**From:** Neil Duffield  
**Sent:** 31 January 2019 17:13  
**To:** Hilary Saunders  
**Subject:** NYM/20108/0653/FL St Athanasius Monastery Langdale End E62 NYMNP details 31-01-19

- Elliot Consultancy Arboricultural report using new topographical survey showing full extent of trees
- D11161-02F, Floor Plans showing minor design alteration, windows to Lower ground
- D11161-03H, Elevations, added windows also materials to externals altered.
- D11161-04B, Revised existing topographical survey produced to show further trees as noted in Astute Ecology Report
- D11161-05E, Proposed Block Plan/Topo, building moved to prevent encroachment on Car Park
- D11161-06B, Amended site sections following building position change
- D11161-07A, Car Parking drawing

CLIENT:	Coptic Orthodox Patriarchate		
PROJECT:	New church at St Athanasius Monastery		
Drawing:	Proposed Plans		
DRAWING STATUS:	Preliminary		
DRAWN:	C Eynon	CHECKED:	N I Duffield
SCALE @ SIZE:	1:100@ A1	DATE:	18/12/17
DRAWING No:	D11161-02		REV: F

DRAWING No: D11161-03	REV: H
--------------------------	-----------

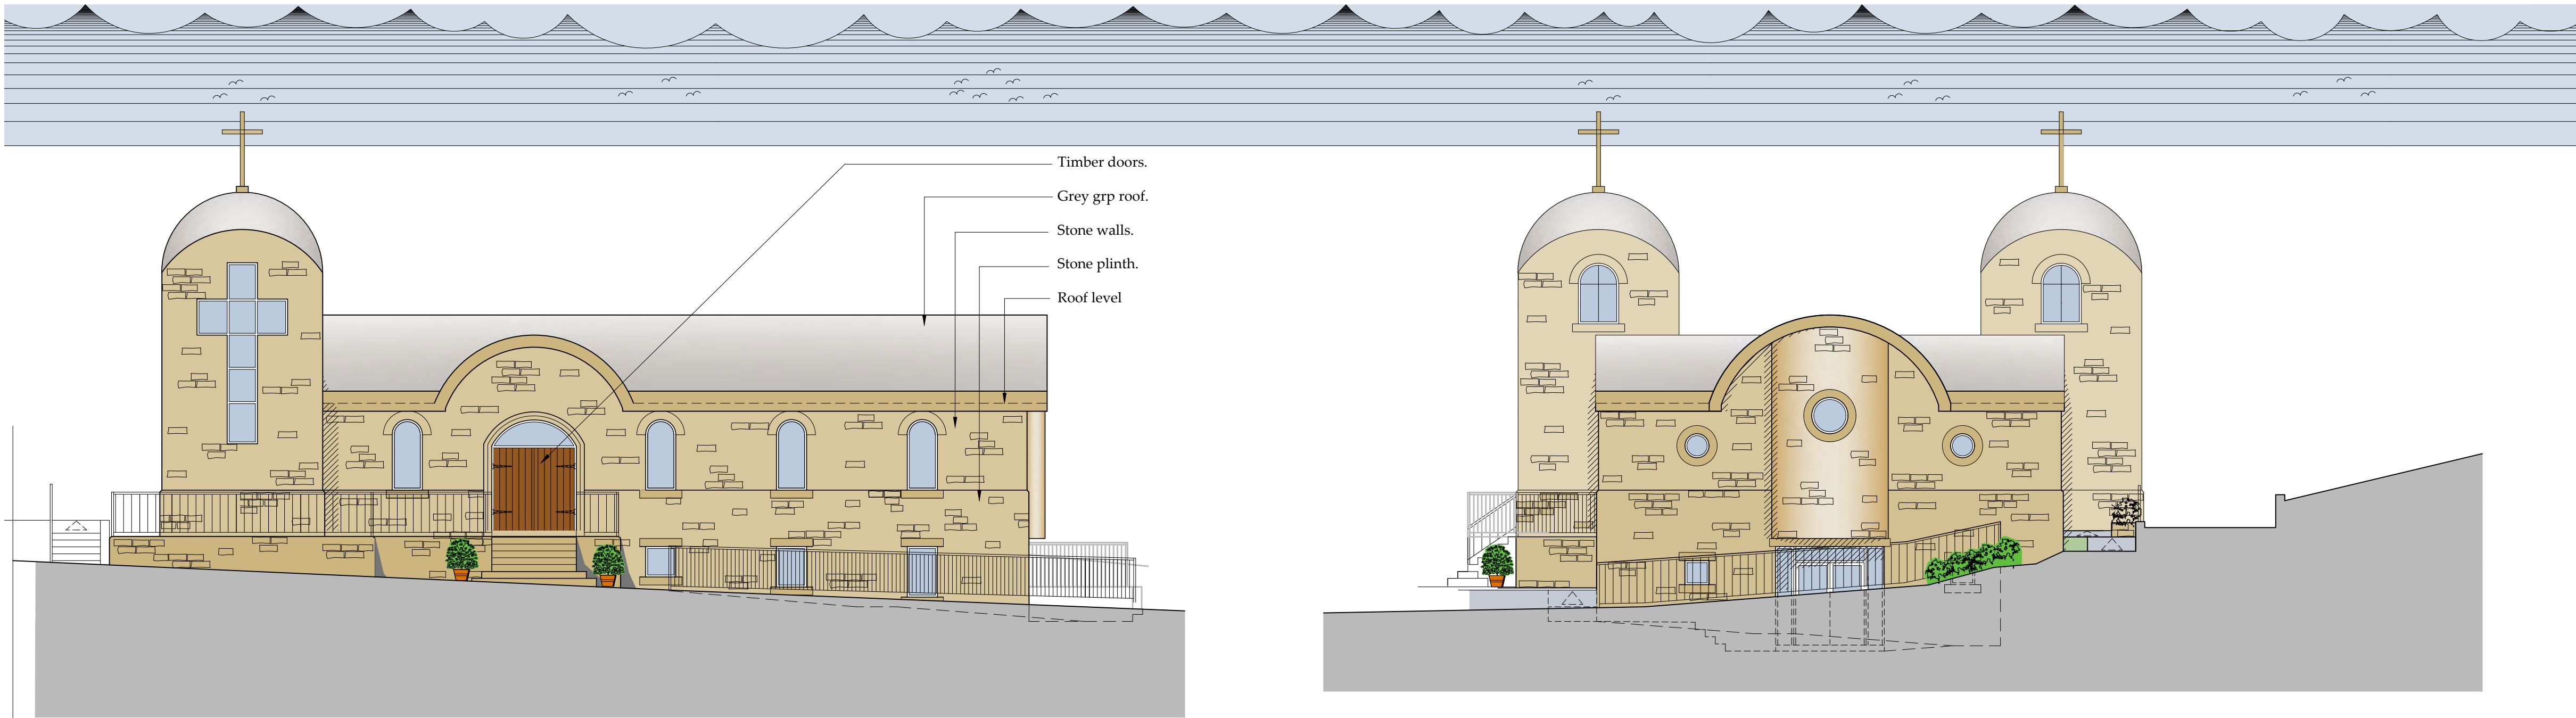
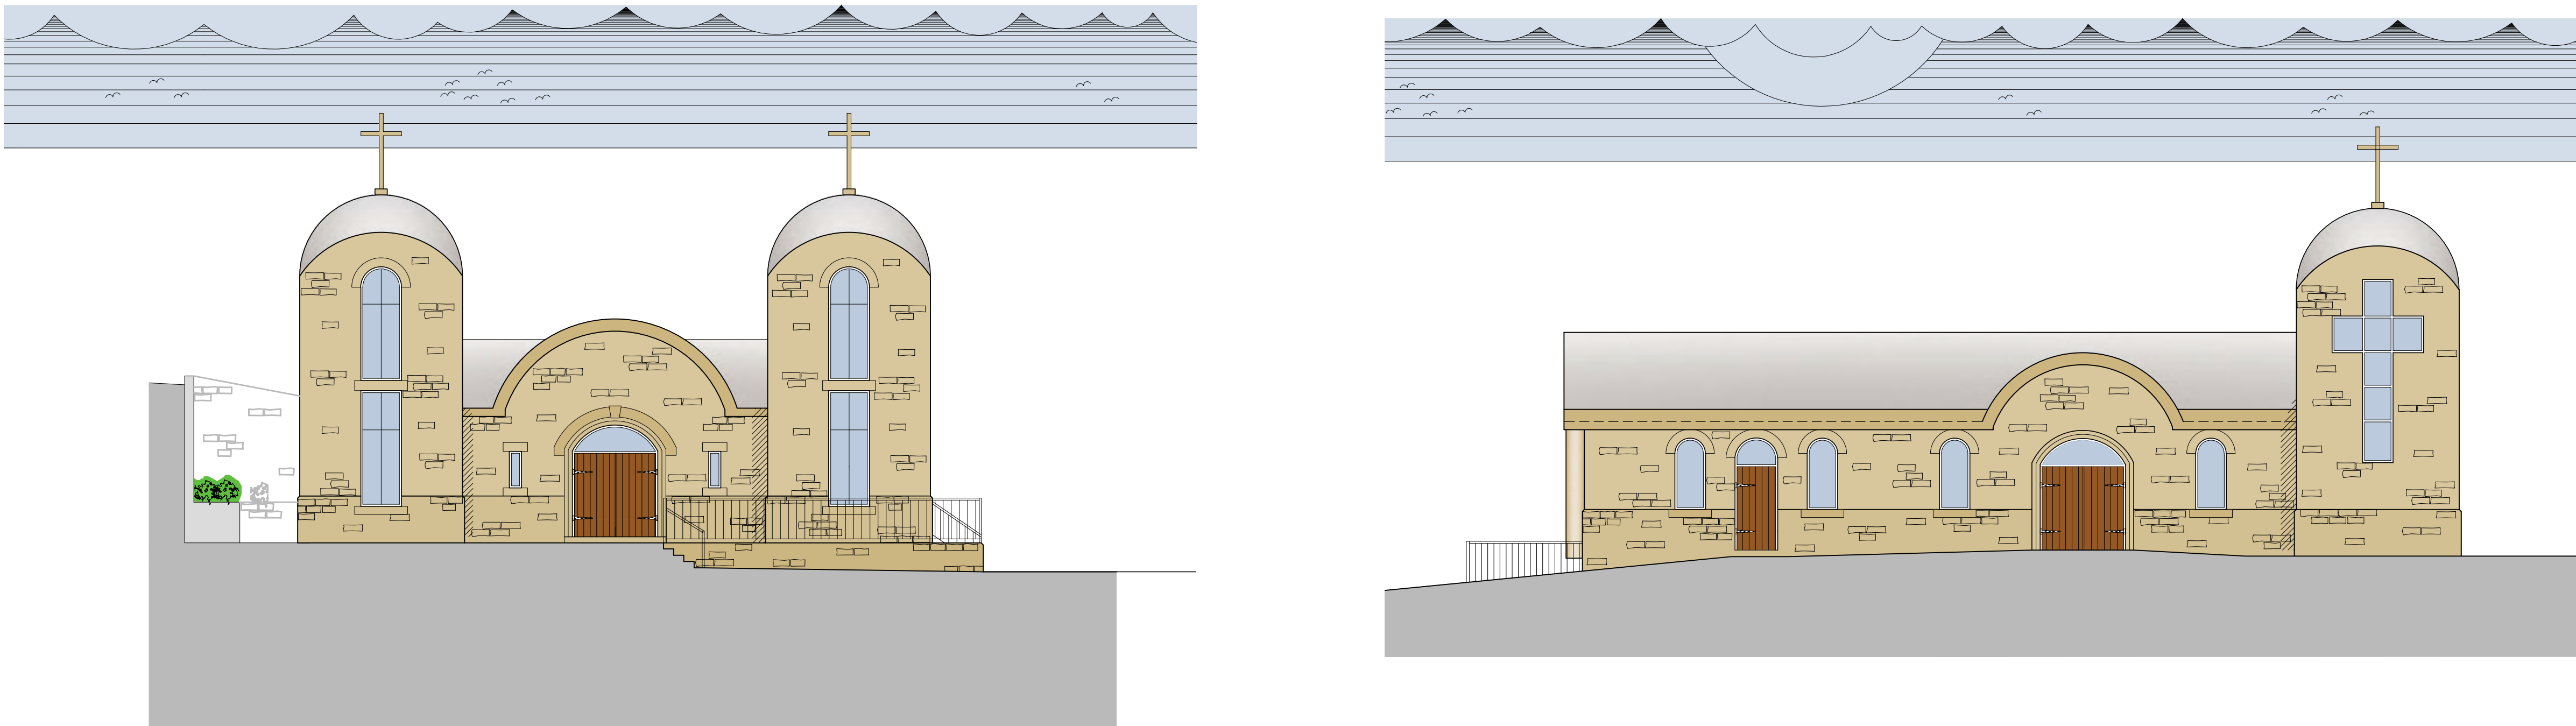
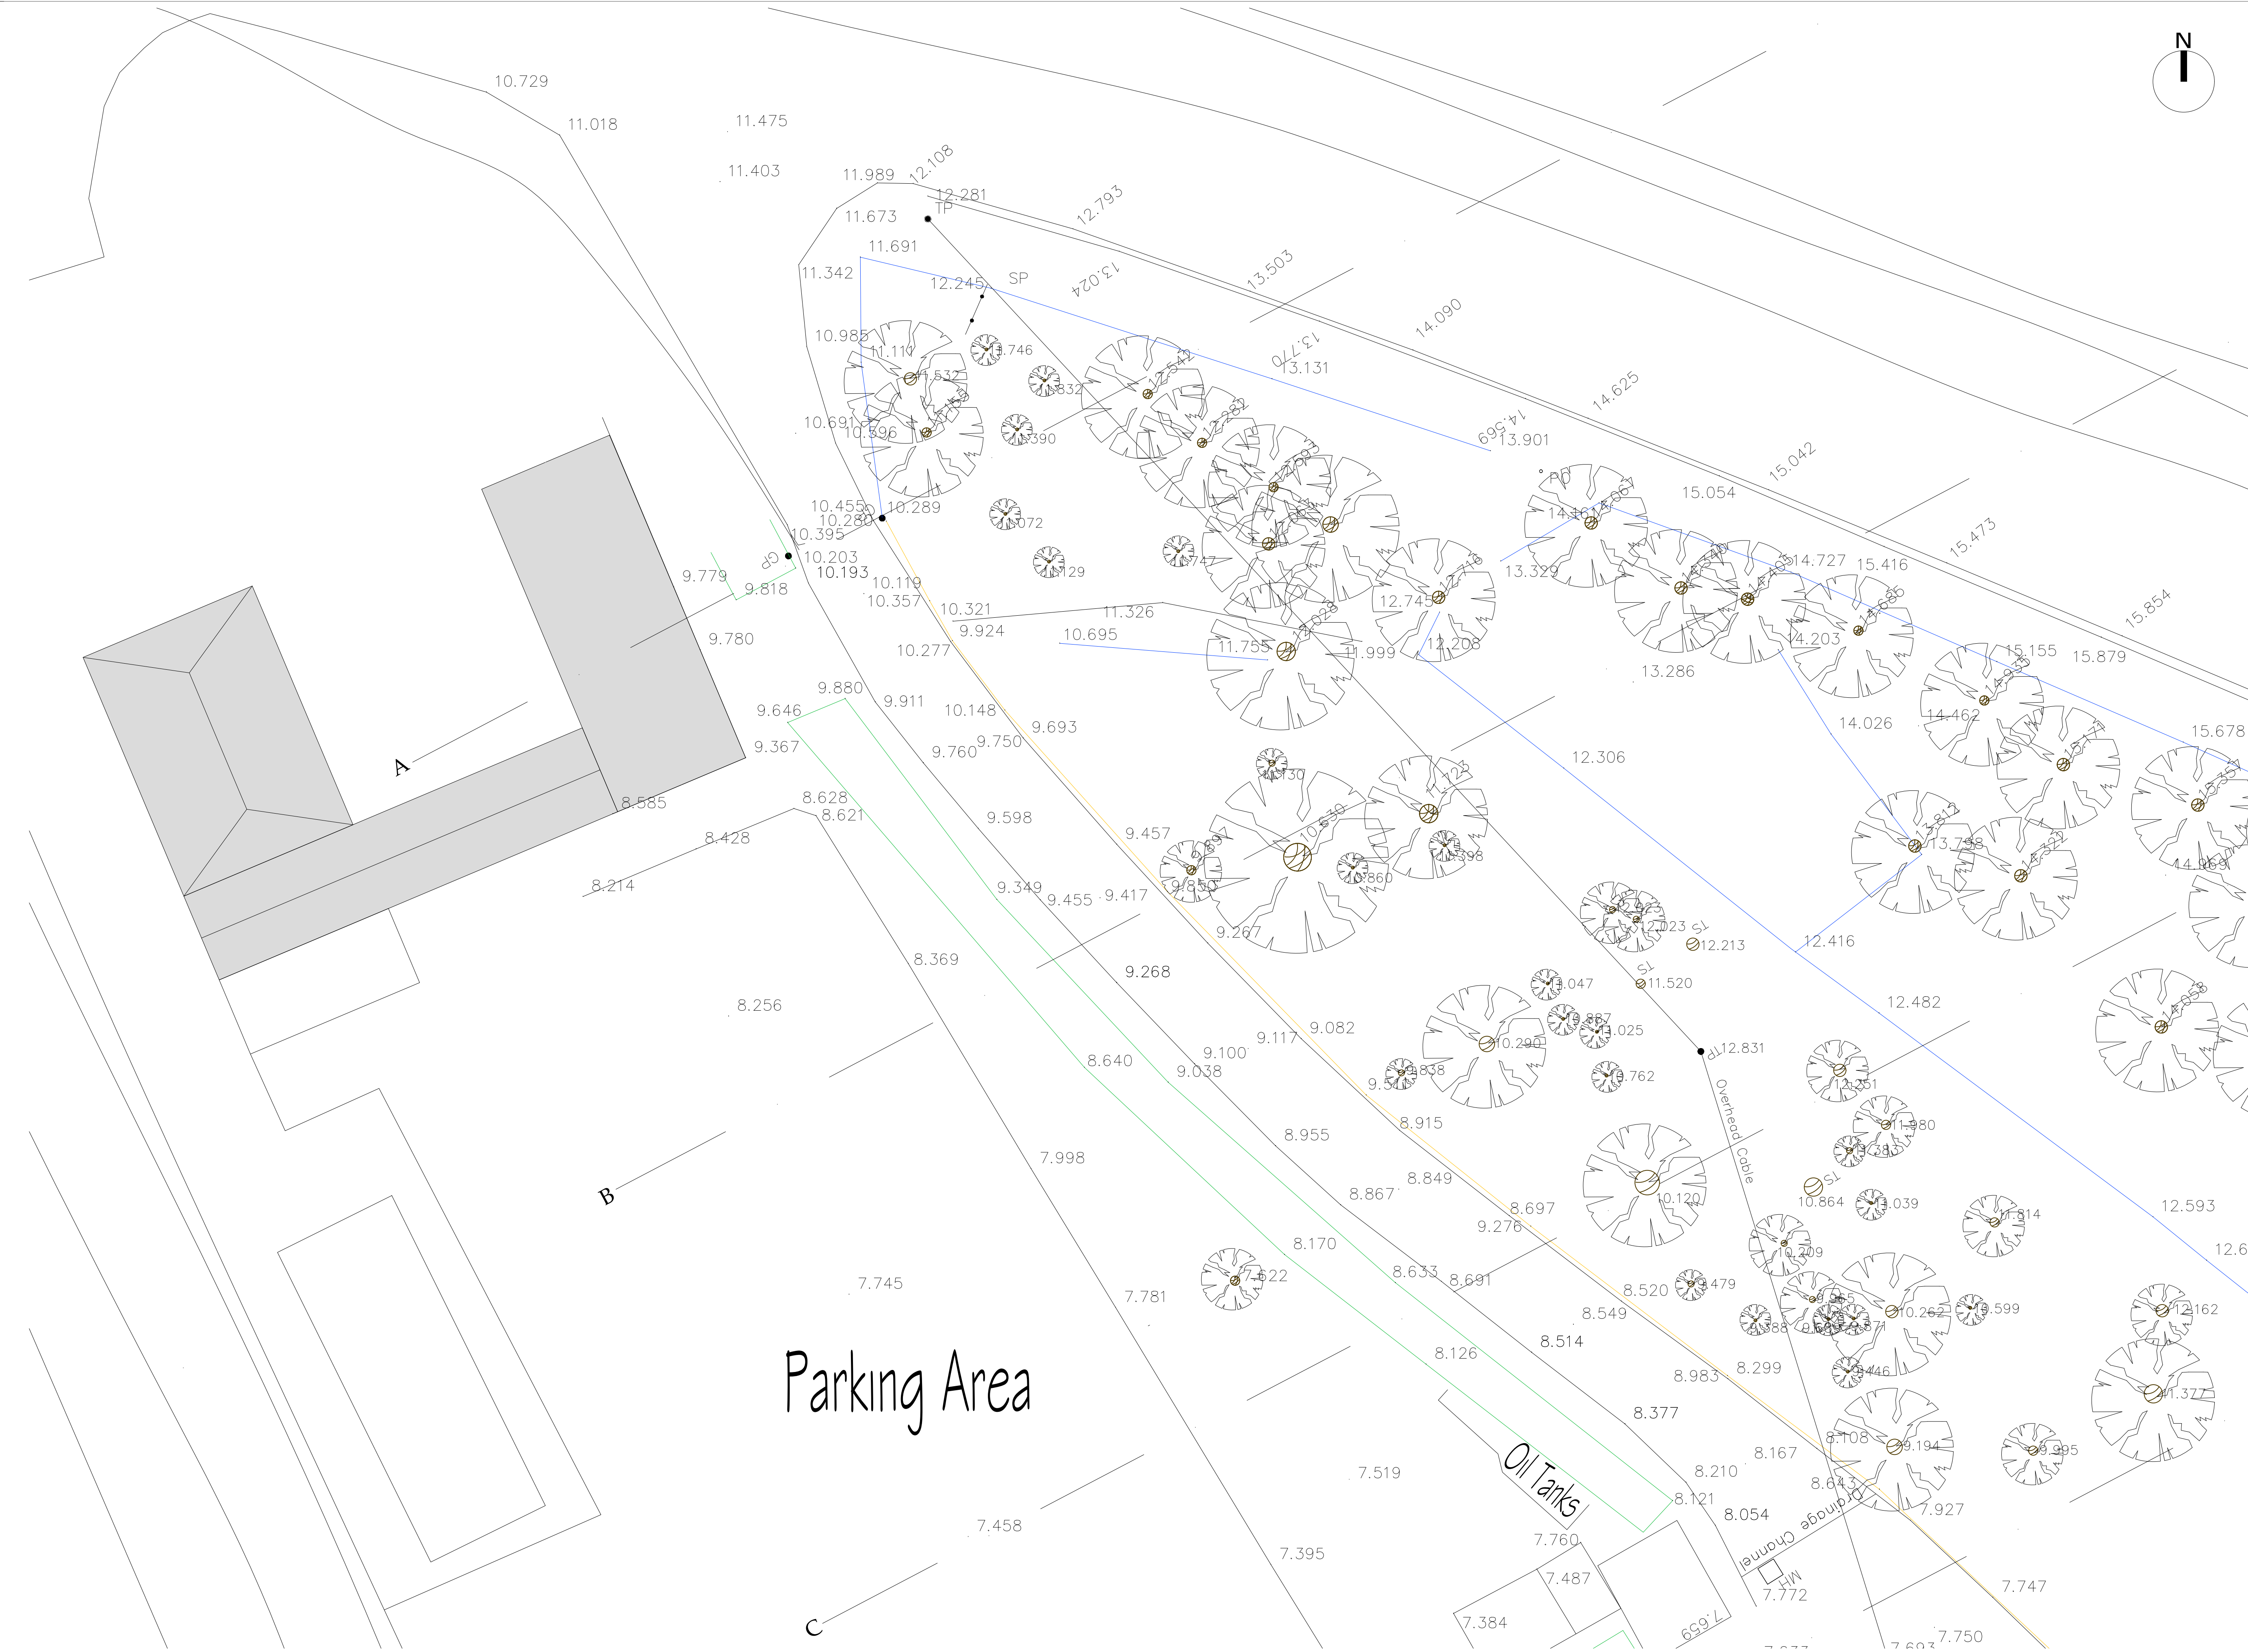
REV	DATE	BY	AMENDMENT
H	29/01/19	CE	Build materials change
G	22/01/19	CE	Lower ground floor windows added
F	15/01/19	CE	Building moved
E	26/10/18	CE	Roof amended
D	24/08/18	CE	Issued for planning
C	12/06/18	CE	Amended to suit clients
B	18/05/18	CE	Amended to suit clients
A	18/12/17	CE	Issued for Approval
